AD-15489-001

Project: 2026 Midfield High School Reroofing Project
Midfield, Alabama

ADDENDUM NO. ONE

This Addendum No. One is being issued to provide additional information, clarification and/or deletions for the 2026 Midfield High School Reroofing Project. Please acknowledge receipt of Addendum No. One on your Bid Proposal Form.

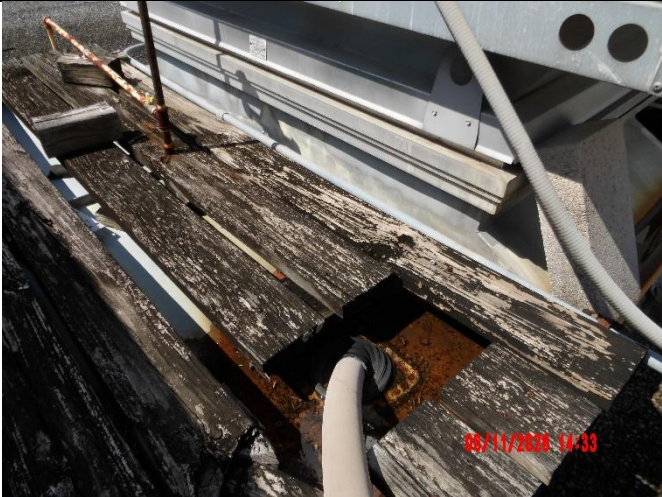
#	Location & Description	Condition Photo
13	Where the base flashing laps are open, prep and apply silicone mastic between the laps and the top surface of the laps prior to coating the base flashings with the specified silicone coating system.	
14	With wet aggregate blast, power-wash the mechanical curb to remove the excess rust. Allow dry time. Apply two (2) coats of the specified high zinc paint to rust areas.	
15	Another typical view of the straight flange expansion joint which needs to be restored. See the Scope of Work for linear footage allowance.
